12 kW Wind Turbine for Iceland: Final Magnet Geometry (P1 generator)

Status: **Rev A, proposed for approval** · 2026-11-05
Owner: Category 4 (Generator) with 10 (Manufacturing and quality)
Builds on: 06 – Generator round 2 (frozen electromagnetic design), 14 – Nacelle prototype P1 (§4.5 magnets, §5.2 air gap budget), 18 – Generator manufacturing (§4.3 magnet purchase spec, §6.4 to §6.8 rotor build)
Analysis: `analysis/generator/magnets.py` → `magnets_summary.json` (2D nonlinear FEA of 7 magnet shapes, magnet eddy loss, demagnetisation, forces, tolerance scatter)
Geometry: `cad/generator_mfg/magnet_geom.py` (all magnet, seat and comb dimensions in this document come from here)
Pictures: `cad/generator_mfg/figures_magnets.py` → detail drawings M01 to M10 and isometric views MI01 to MI04; illustrated PDF in the project folder

Decision proposed: buy flat magnets. Each pole is made of **four identical flat N40UH blocks, 18.75 × 36.90 × 8.20 mm**, two side by side and two along the stack, magnetised straight through the 8.20 thickness. The same block is used for north and south poles: it is simply turned over. This replaces the 168 curved arc segments of doc 18 (two part numbers, N and

M01 Four ways to make one magnet pole: curved arc or flat blocks

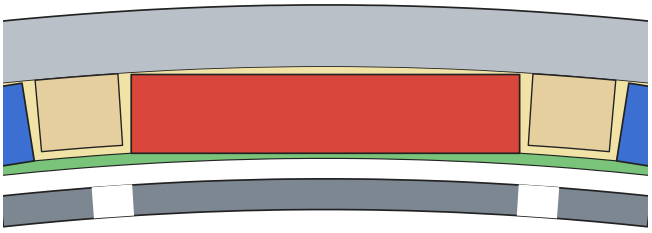
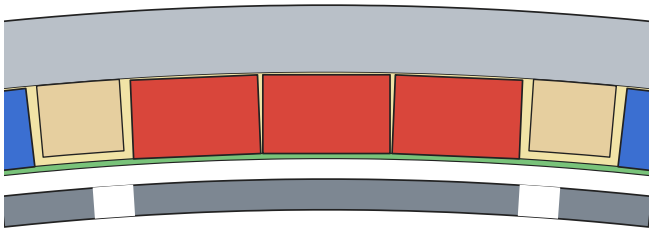
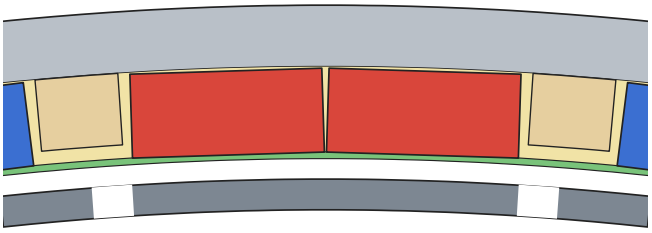
A Curved arc 7.7 (doc 18)

EMF 387 V torque 803 Nm cogging 1.01 Nm
magnet heat 11 W with 4 pieces along · magnets 6.65 kg
2 part numbers (N and S), ground curved faces

F1 One flat block 7.7

EMF 364 V torque 755 Nm cogging 1.06 Nm
magnet heat 9 W with 4 pieces along · magnets 6.57 kg
bond 0.73 mm thick in the middle, −6 % EMF

F3 Three flat blocks 7.7

EMF 376 V torque 780 Nm cogging 1.58 Nm
magnet heat 8 W with 2 pieces along · magnets 6.46 kg
1 part number, but 240 small pieces

F2t Two flat blocks 8.2 chosen

EMF 381 V torque 790 Nm cogging 0.96 Nm
magnet heat 13 W with 2 pieces along · magnets 6.92 kg
1 part number, turn it over for S. 160 pieces

M03 Detail drawing NP1-220 Rev C Magnet block (bought part)

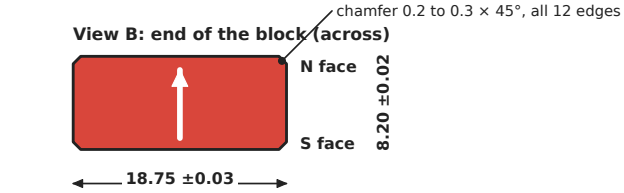
Flatness of N and S faces 0.02
Parallelism N to S face 0.02
Squareness of the sides to the N face 0.05
Magnetic axis within 2° of the face normal

Part	NP1-220 Rev C magnet block (replaces NP1-220-N and -S arcs)
Material	Sintered NdFeB N40UH, Br ≥ 1.26 T, HcJ ≥ 1990 kA/m (20 °C)
Magnetised	Fully, parallel, through the 8.20 thickness
Coating	NiCuNi ≥ 15 µm + epoxy ≥ 15 µm (total 30 to 45 µm, in the sizes)
Mark	White dot Ø3 on the N face, one corner
Mass	43.1 g each
Quantity	160 + 8 spare + 8 test pieces per generator
Moment	Each piece within ±1.5 % of the lot mean, value per serial
Surfaces	Faces ground, Ra ≤ 1.6 before coating
Scale	10 : 1 on this sheet

M02 Why flat is easier: ONE magnet part, turned over for the other pole

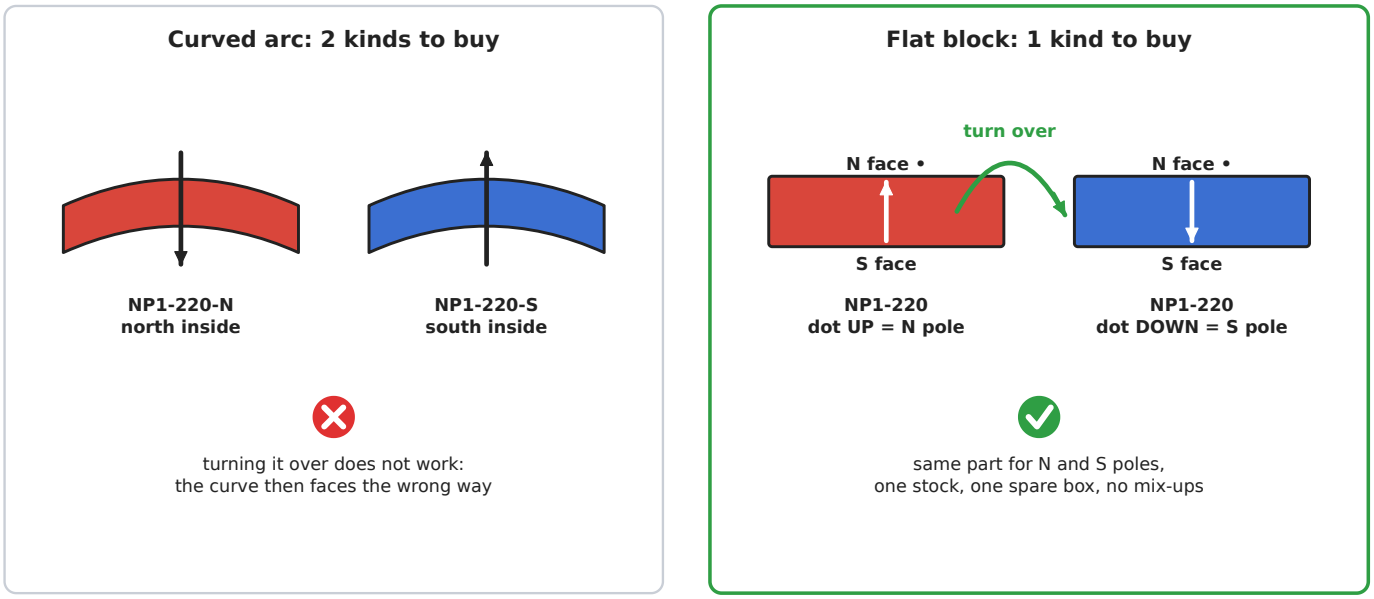
A flat block is magnetised straight through its thickness. Turn it over and the north face points the other way.

At an N pole the block goes in **dot up** (N face towards the stator); at an S pole the same block goes in **dot down** (N face against the drum). This removes doc 18 M7 completely: one part number, one stock, one spare box.

M04 Detail: one pole of two blocks on the drum seat (cross-section, 20× real size)

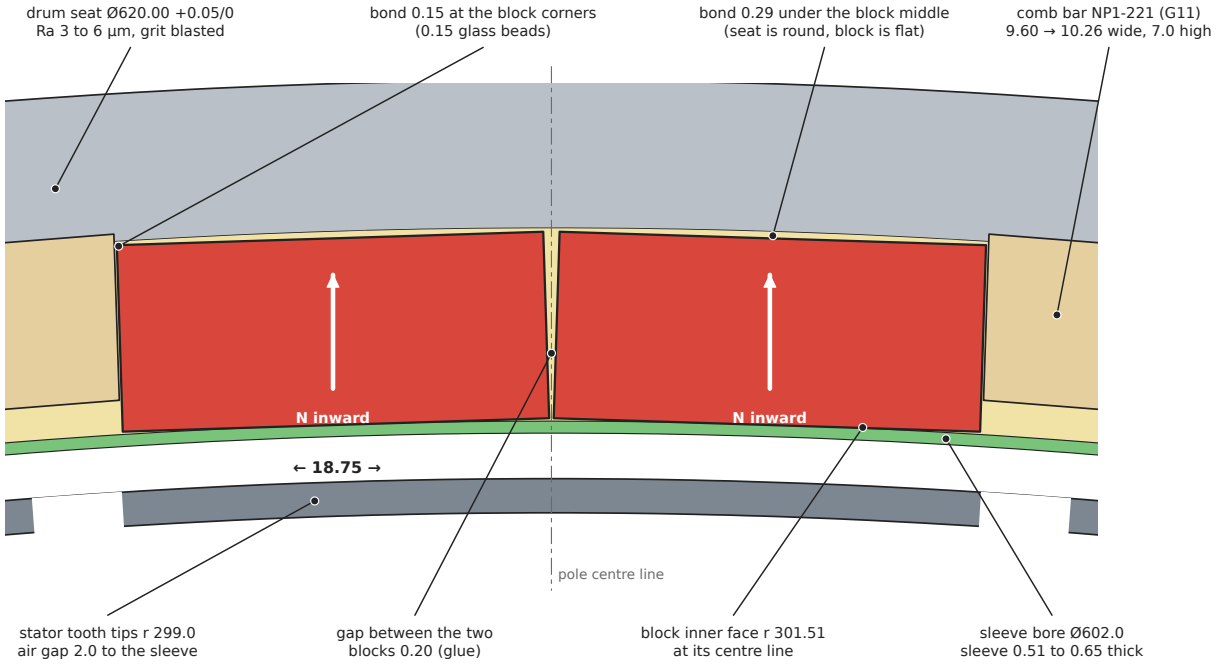
Pole pitch 9.000°, pole span 7.20°, block centres at ±1.80°
Blocks: 18.75 × 36.90 × 8.20, magnetised through 8.20
Drum yoke under the seat: 13.0 mm (shell OD Ø646)

Feature	Value (radii from the generator axis)
Pole pitch / span	9.000° / 7.20° (unchanged); block centre lines at ±1.80° from the pole centre
Drum seat	**Ø620.00 +0.05/0**, x 335 to 425, run-out ≤ 0.02 to the cup seats, Ra 3 to 6 µm after grit blasting
Bond line	0.15 at the block corners (0.15 mm glass beads), 0.29 under the block middle
Block inner face	r 301.51 at the block centre line, r 301.65 at the block edges
Sleeve	Moulded on the Ø602.0 mandrel: 0.51 thick at the block centres, 0.65 at the block edges
Gap between the two blocks of a pole	0.20 at the inner corners, widening to 0.72 at the outer corners (glue)
Comb bars NP1-221	G11, trapezoid 9.60 (inner) to 10.26 (seat side) × 7.0 high × 82.0 long, faces at 2.70° to the bar centre line so they lie flat against the neighbouring blocks
End rings NP1-222	G11, OD Ø620.0 −0.1/−0.2, ID Ø604.0, 8.0 wide, 40 notches for the comb bar ends
Axial layout	Block rows x 343.0 to 379.9 and x 380.1 to 417.0, 0.2 mm PTFE shim between rows (removed after cure)

M06 Where every block goes: the drum seat unrolled, seen from the stator

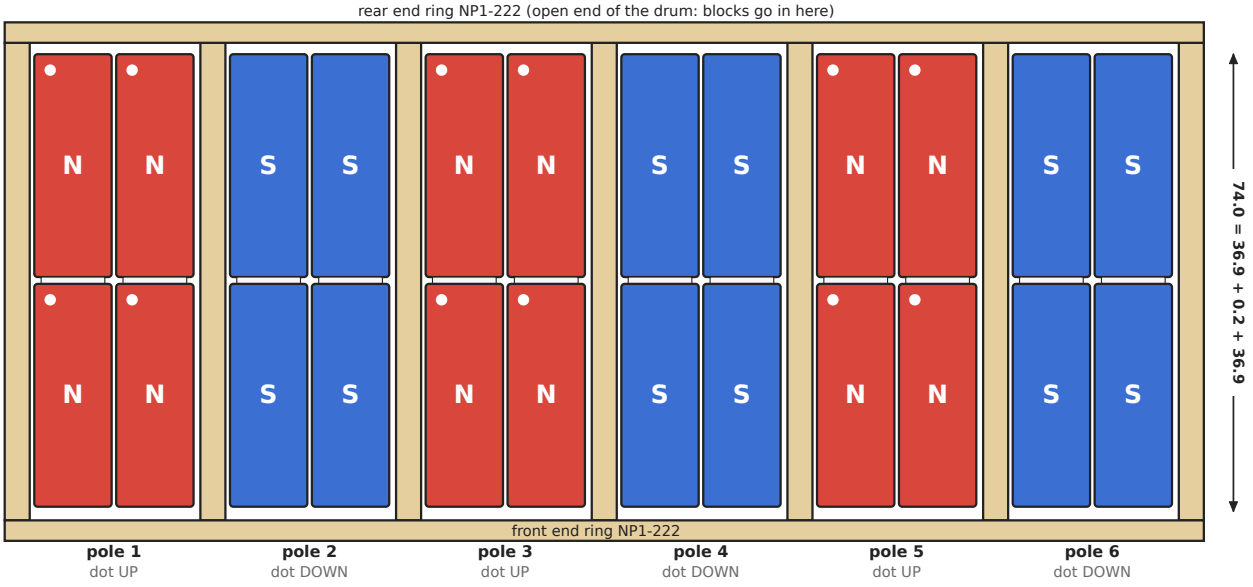
Part of the ring, 6 of the 40 poles. Each pole = 2 blocks across × 2 blocks along = 4 blocks of the SAME part.

- white dot visible = N pole (dot faces the stator)
- dot hidden against the drum = S pole
- N and S always alternate, 20 + 20 poles

M07 From the drum to the stator: every layer and its tolerance (radial, mm)

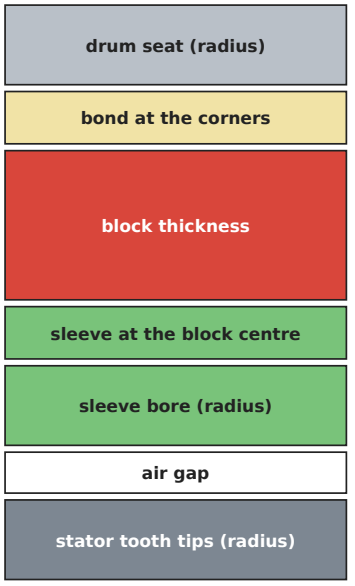
The sleeve is moulded on the Ø602.0 mandrel, so magnet and bond scatter only change the sleeve thickness, not the air gap.

Reject a drum if the seat is smaller than Ø620.00: the blocks would push into the sleeve space. Larger seat: just thicker sleeve.

Radial. The sleeve is moulded on the mandrel, so the magnet and bond scatter only change the sleeve thickness, not the air gap (doc 18 M6). With seat +0.05/0 on the diameter, bond +0.05/0 and block ±0.02, the inner face at a block centre lies between r 301.49 and r 301.60: the sleeve is 0.49 to 0.60 at the block centres and up to 0.75 at the block edges, inside the 0.4 to 0.8 range to be qualified on Q1. A drum with a seat smaller than Ø620.00 is rejected. The doc 14 air gap budget item “magnet thickness and bond line 0.050” drops out of the gap budget (it is replaced by the mandrel and sleeve bore tolerance already in doc 18 §6.8).

M09 When the box arrives: 6 checks for every block (in the magnet room)

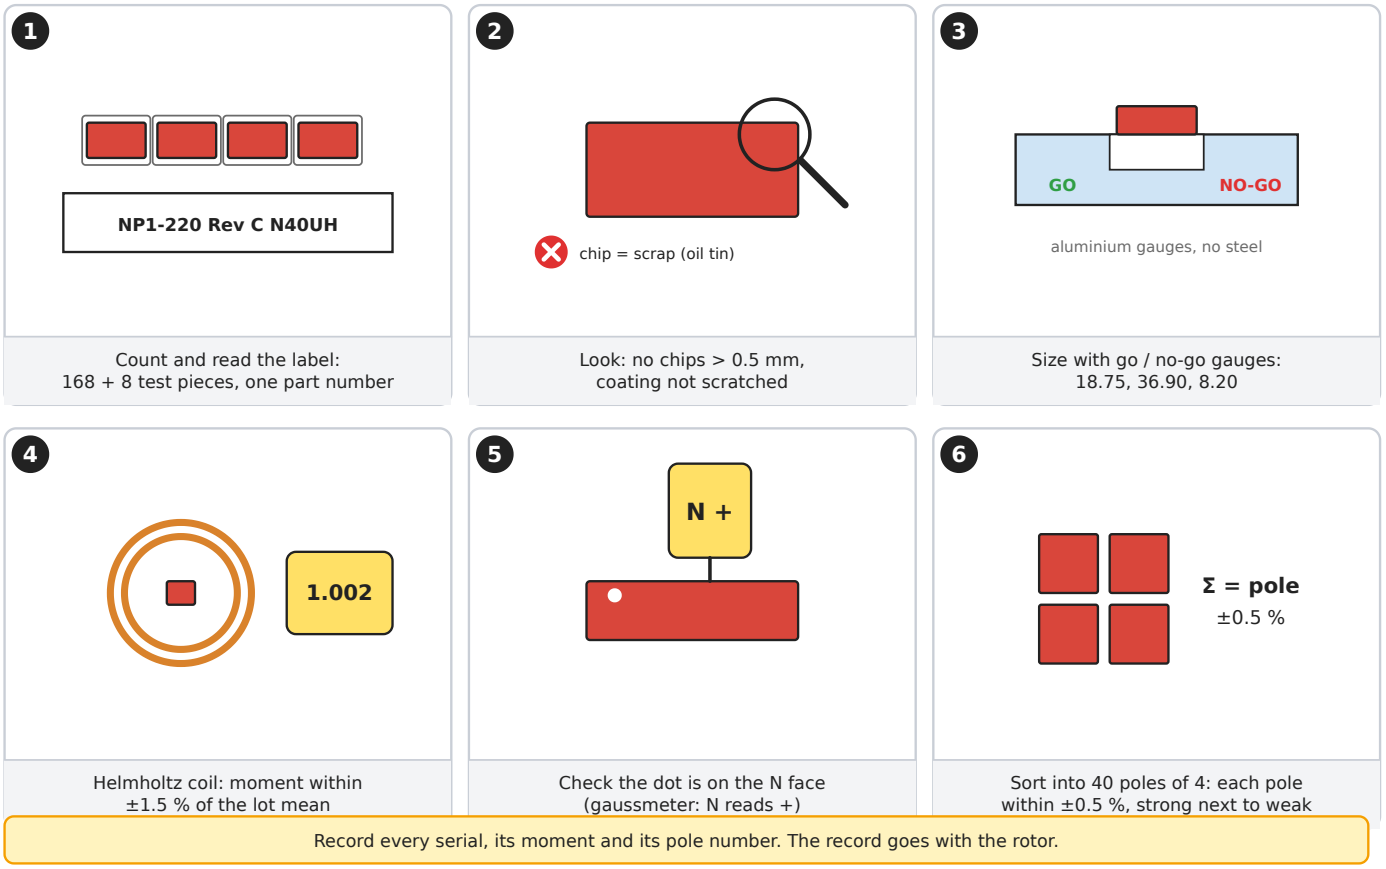
Incoming inspection replaces doc 18 §6.5 “receive and sort”: count, look (no chips > 0.5 mm), size with aluminium go/no-go gauges, moment in the Helmholtz coil (±1.5 % of the lot mean, within ±1 % of the supplier’s value), check the dot is on the N face with the gaussmeter, then **sort into 40 poles of 4 blocks** with pole sums within ±0.5 %, strong and weak poles alternating.

M10 Glue one pole: 4 blocks of the same part, with the jig NP1-T02 (Rev C shoe)

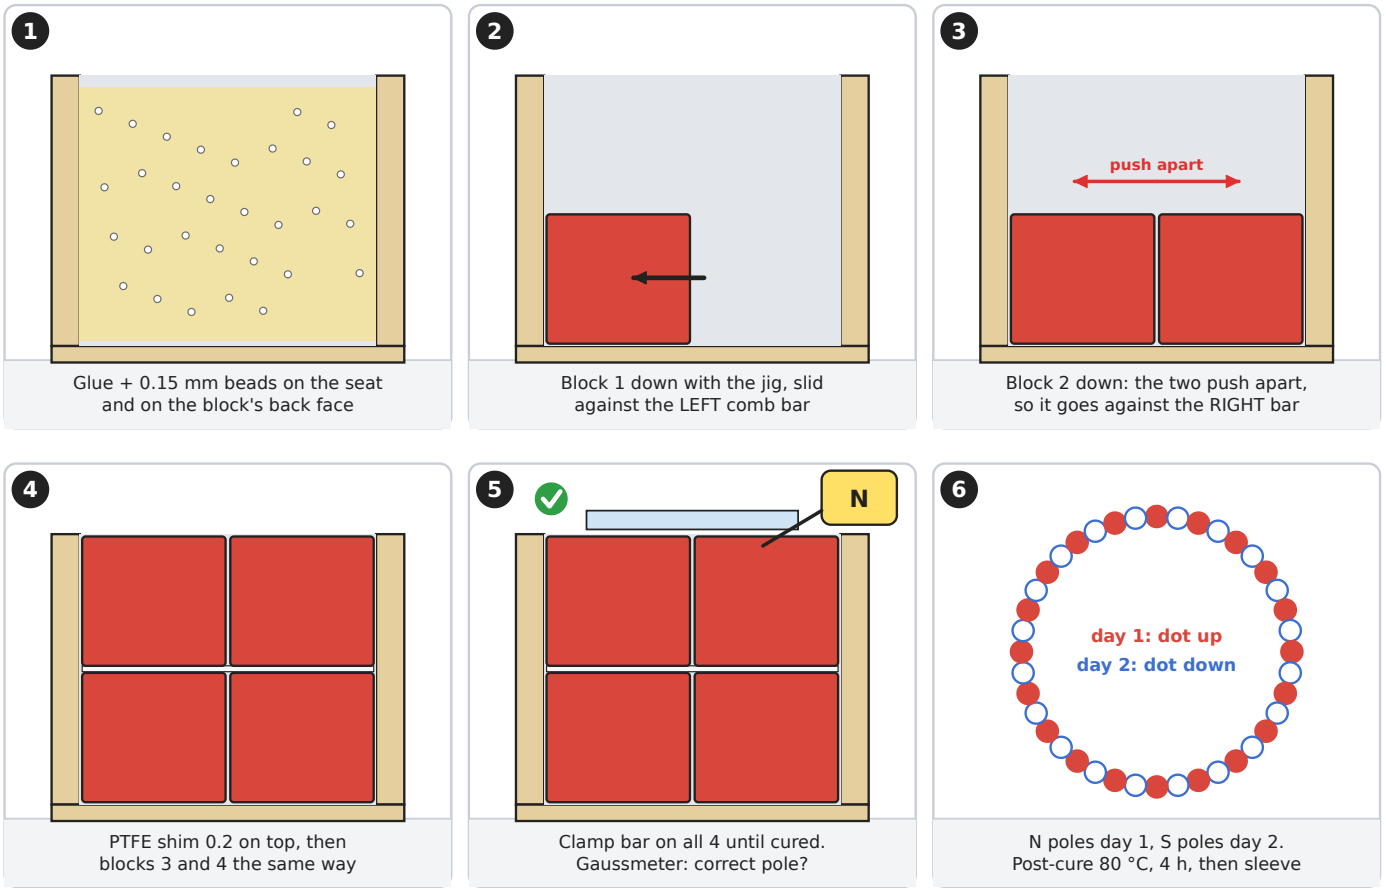
Bonding is as doc 18 §6.4 and §6.5 with these changes:

1. Comb bars NP1-221 are trapezoid (wide face on the seat) and their ends sit in the notches of the end rings NP1-222; locate notch 1 from hub bolt hole 1.
2. The jig NP1-T02 gets a **Rev C shoe**: a flat POM pocket 18.85 × 37.0 with the block held dot up (N poles) or dot down (S poles).
3. Per pole: block 1 against the left comb bar, block 2 next to it (it moves against the right bar by itself), PTFE shim 0.2, then blocks 3 and 4 the same way, clamp bar on all four until cured.
4. N poles first (all 20, dot up), cure, then S poles (dot down); gaussmeter check of every pole before the glue gels.
5. Pole map (doc 18 §6.6) with the pole centre limit tightened to **±0.05°** (§7); the axial uniformity check now looks for a dip over the single row joint at x 380.
6. Comb bars are placed with the indexing template to **±0.03°** (±0.16 mm).
